City of West Allis

Plan Commission

2. [25-0265](#) Site, Landscaping, and Architectural Design Review for F Street 92, LLC, a proposed 5+ Unit Dwelling use, at 1405 S. 92nd St. (Tax Key No. 450-0502-000)

DATE: 7/17/2025
 TO: City of West Allis
 CC: Ryan Neidinger – RINKA
 PROJECT: 92nd and Greenfield Multifamily
 PROJECT NO.: 24101
 RE: Responses to City Staff Plan Commission Comments

GRADING PLAN

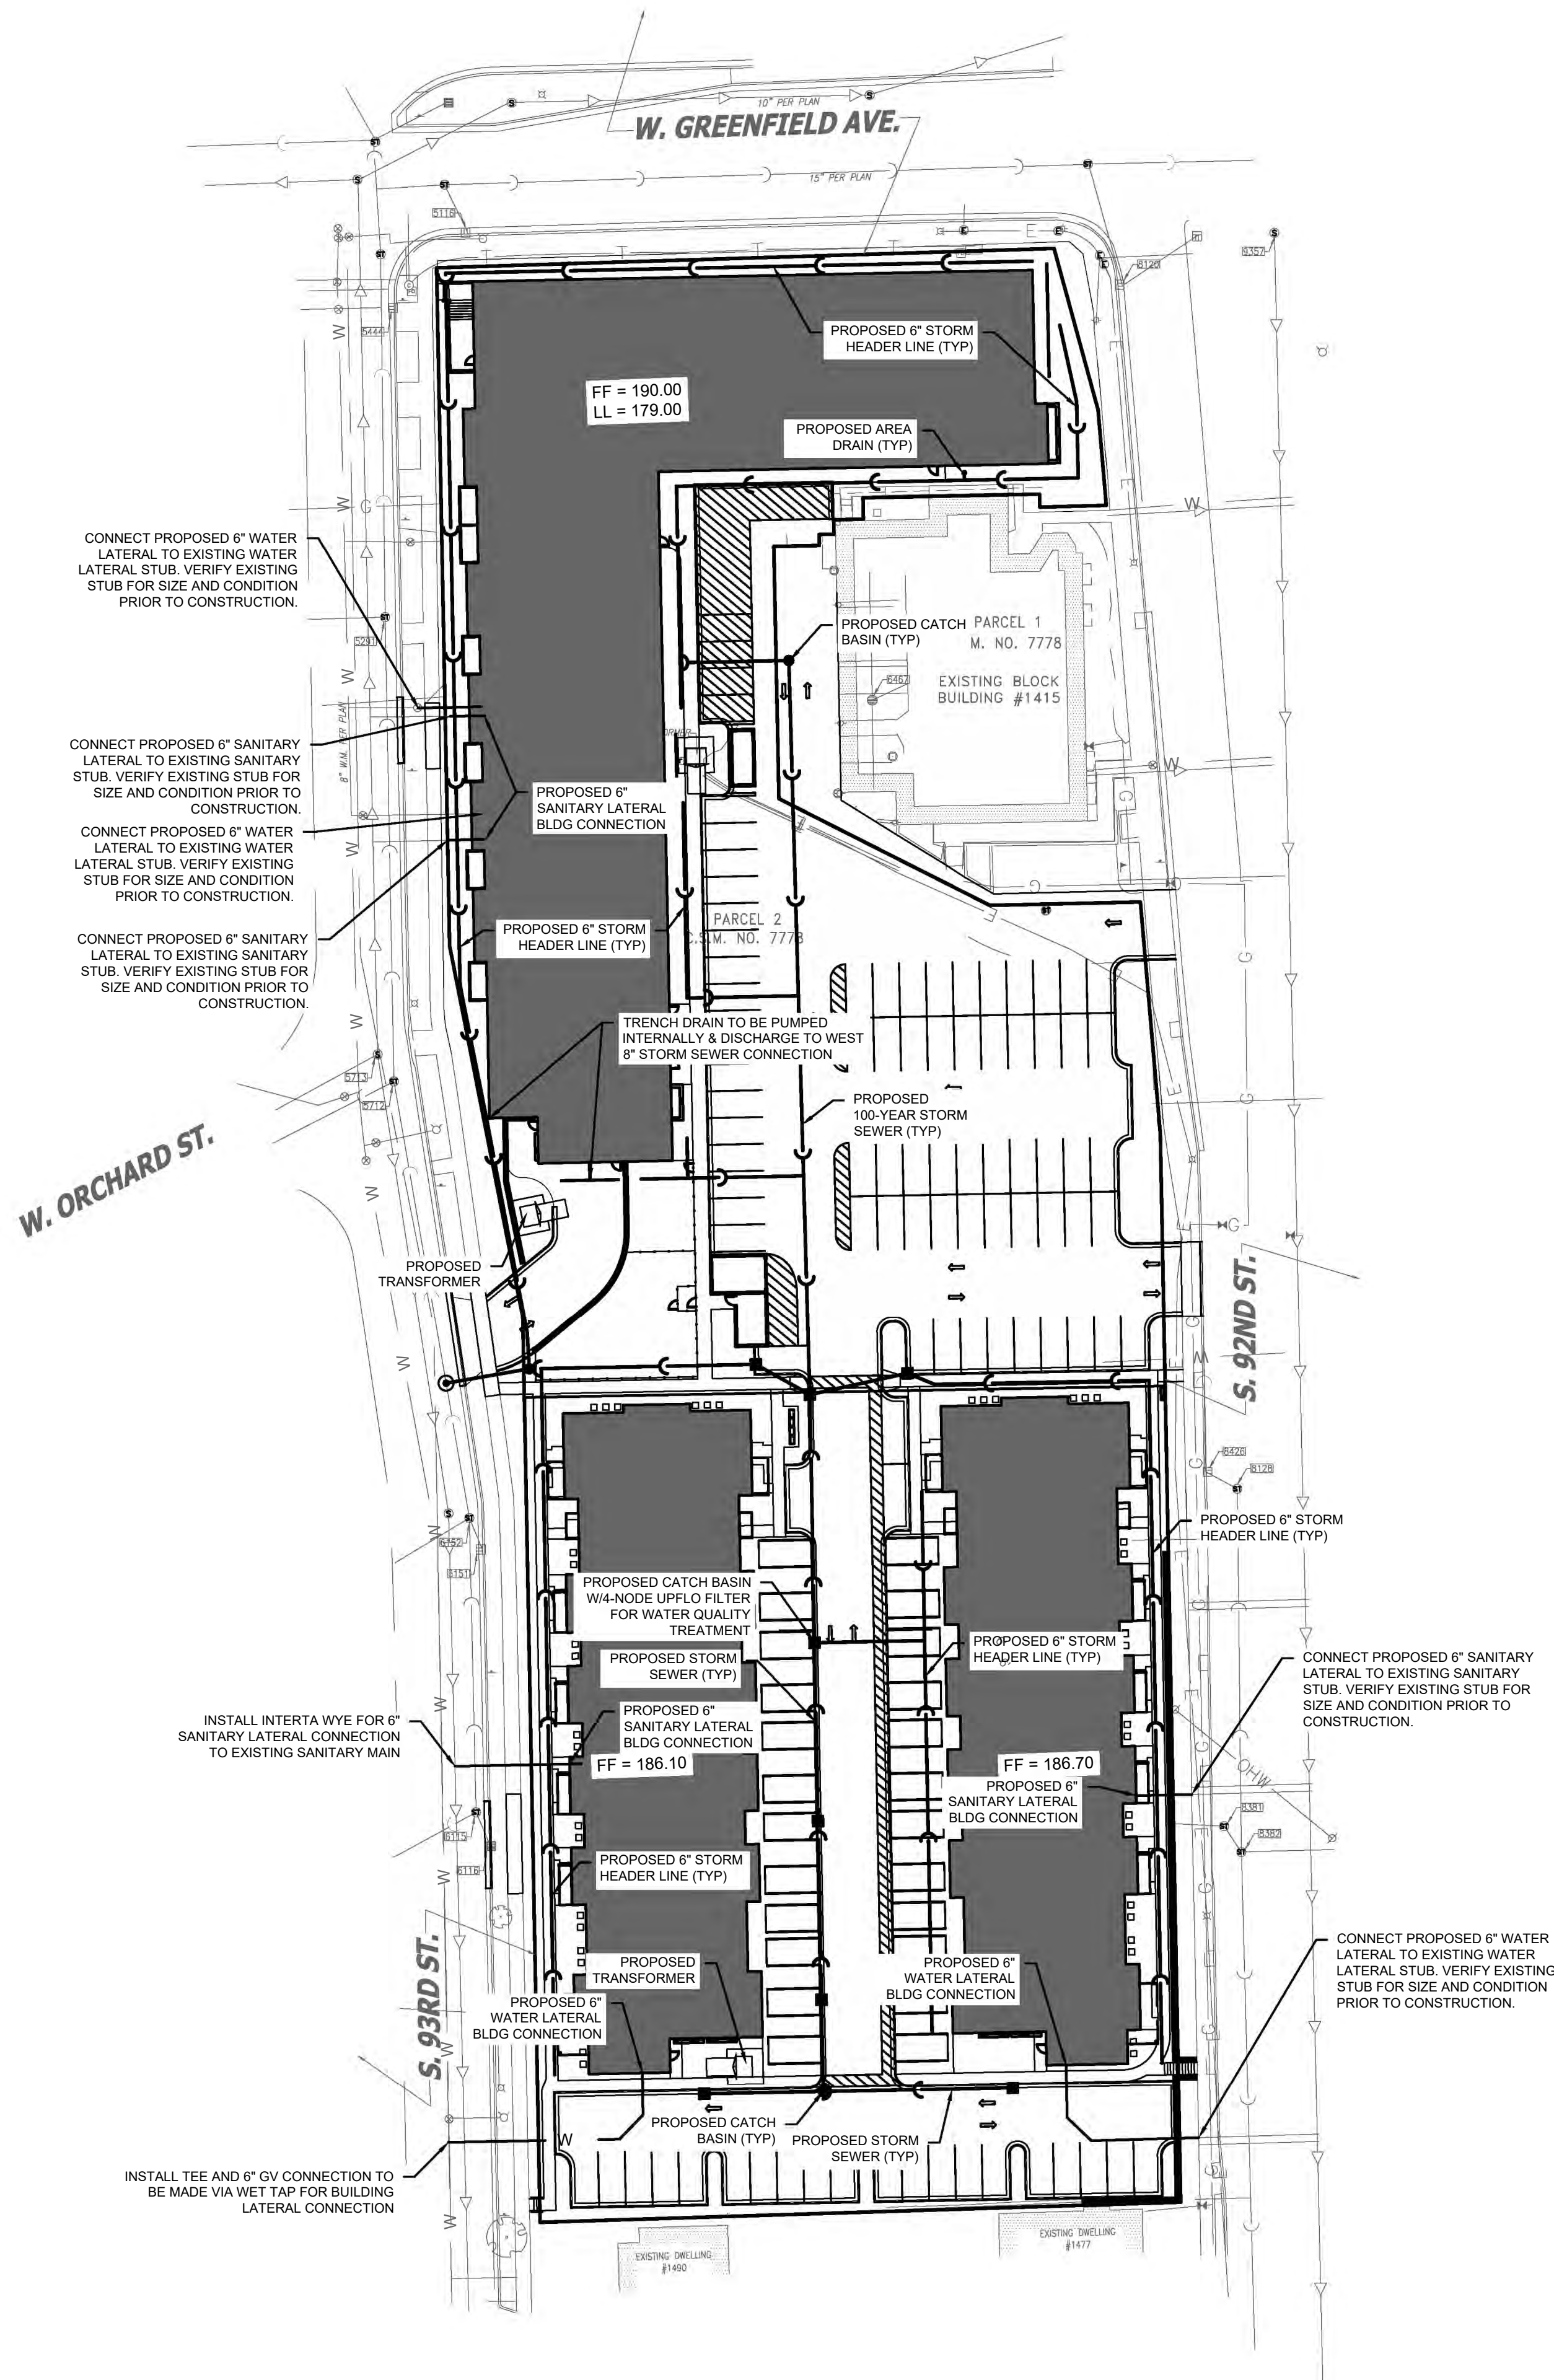
10. Retaining wall type and detail

Pinnacle Response: Landscape block, color to compliment the building.
